## SERVICE BULLETIN

#0017

**SUBJECT:** Potential risk of shearing of control stop plate rivets

**MODELS AFFECTED:** Sling 4 and Sling 4 TSi aircraft

Figure 1 - Elevator control torque tube for Sling 4 and Sling 4 TSi aircraft

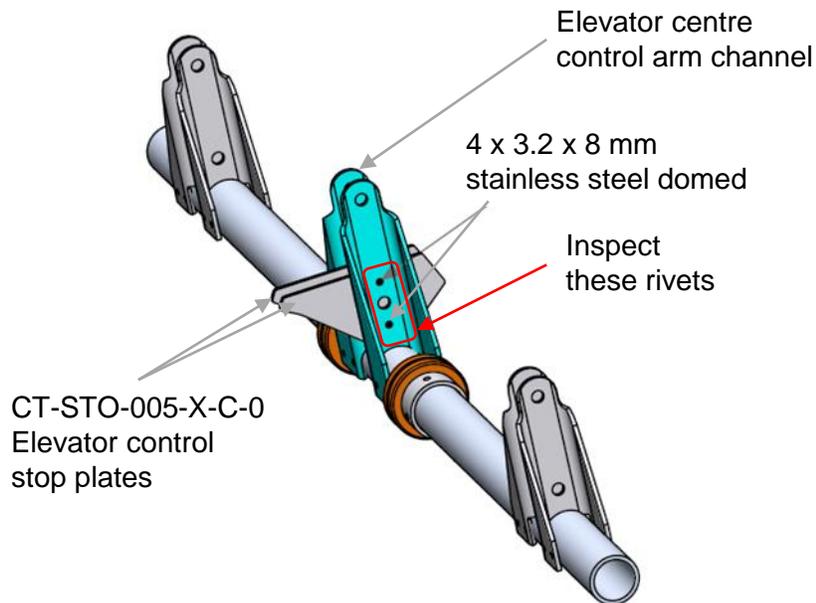
1. The rivets on the torque tube that need to be inspected are shown in Figure 1. The control stop plates (CT-STO-005-X-C-0) and elevator centre control arm channels are also shown in Figure 1.
2. Remove a front seat from the fuselage then use the 2 mm / 2.5 mm Allen key to remove the floor skin (refer to CF-SKN-016-R-C-0) shown in Figure 2.
3. The inspection region when the floor skin is removed is shown in Figure 3. Use the light source to determine if control stop rivets are aluminium or stainless steel. Use Figure 4 as a guide for making the distinction.
4. Alternatively (or in addition to using the light source) use a magnet to identify rivets. The mandrel of the aluminium rivet used is magnetic, so a magnet will attract to the aluminium rivet (see Figure 4).

Figure 3 - Region of inspection area and seat rail

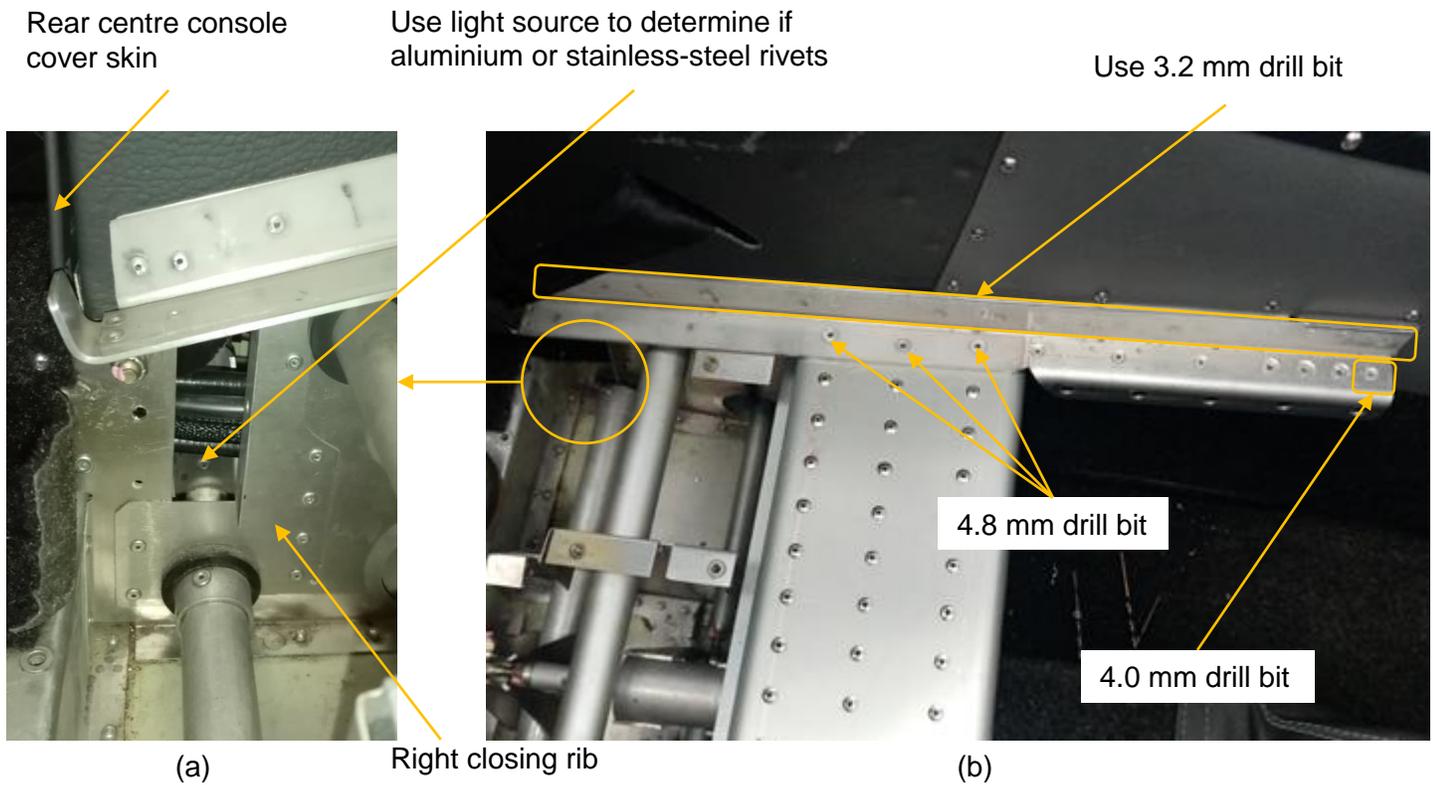
7. Drill the heads off the countersunk rivets shown in Figure 3(b) with the angle drill (using 3.2 and 4.8 mm drill bits) to remove seat rails.
8. Remove and retain all M3 / M4 screws on the aft section of the centre console to separate it from the forward section as shown in Figure 5(a).

11. Cut the cable ties that guide the centre console wiring and pitot static tubes (using the side cutter) to reduce their tautness, then use the angle drill and 3.2 mm drill bit to drill heads off the rivets on the closing rib as shown in Figure 5(b). The closing rib on the centre console RH side is shown in Figure 3(a).

17. The AN4 lock-nuts (hardware designation AN365-428A) must be tightened such that the seat belt brackets can still swivel.
18. Install the controls closing ribs (CF-RIB-009-R/L-C-0 shown in Figure 3(a)) using the 3.2 mm clecos to align the holes. Assemble with (20) 3.2 x 8 mm aluminium domed rivets.

Figure 5 – Disassembly of centre console and removal of CF-RIB-009-R/L-C-0

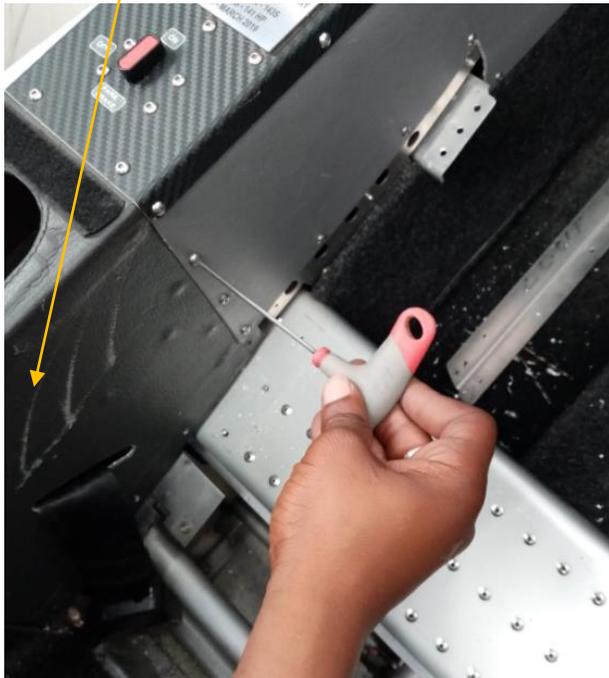
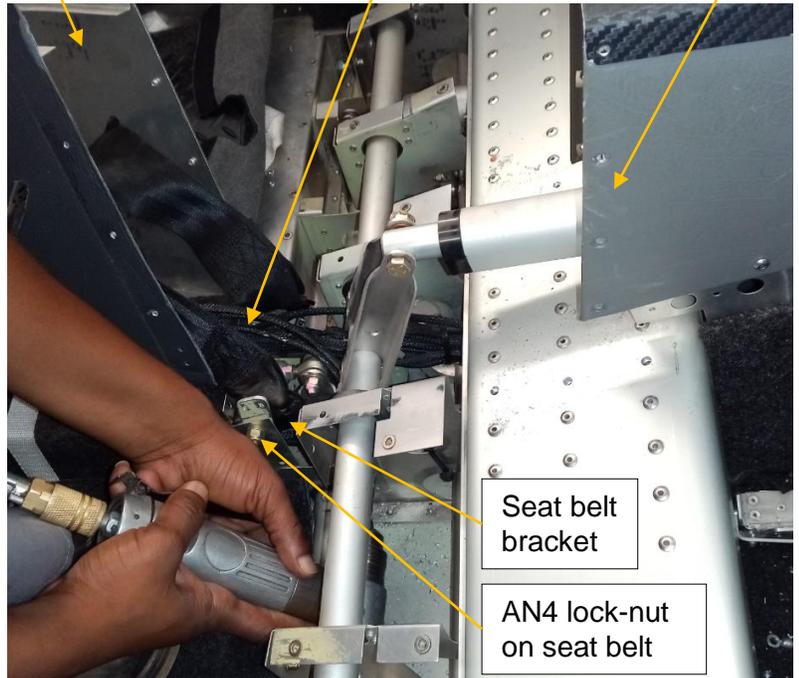
9. The aft section of the centre console must be carefully pulled away so as not to damage wiring and pitot static lines running through the console as shown in Figure 5(b). If resistance is felt separating the aft and forward centre console sections, the headset jacks should be removed with the 14 mm spanner and socket. Be sure to label these cables left and right so that they are refitted in their original positions (see Figure 6).

12. Use the 7/16" spanners to loosen the AN4 lock-nuts (hardware designation AN365-428A) on seat belt shown in Figure 5(b) so that the seat belt bracket can swivel. This will ensure there is sufficient room for the hand riveter to be pressed firmly against elevators' centre control arm channel when installing the 3.2 x 8 mm stainless steel rivets (See Figure 7).

19. Return the aft section of the centre console using the 2 mm / 2.5 mm Allen key and install the M3 / M4 screws (see Figure 5(a) which shows disassembly).

Figure 7 – Installation of stainless steel rivets

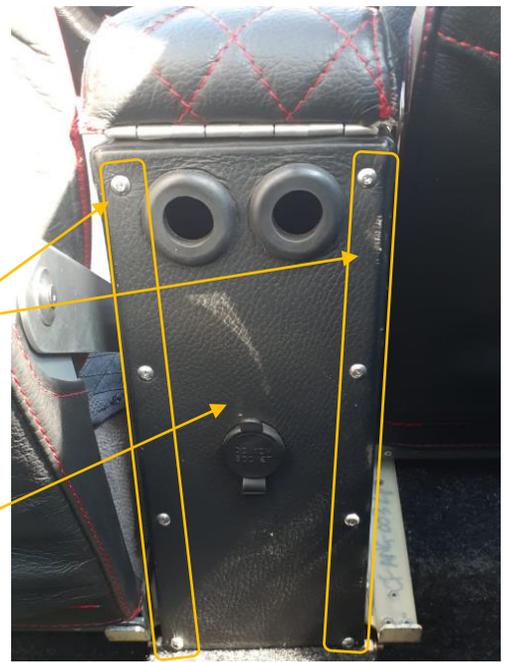
13. On the control stop plate, remove the aluminium rivet and install the 3.2 x 8 mm stainless steel rivet. Apply this remedy one rivet at a time to prevent the control stop plate from detaching from the control tube.

14. Be sure to press the hand riveter firmly against the elevators' centre control arm channel so that the rivet "catches".
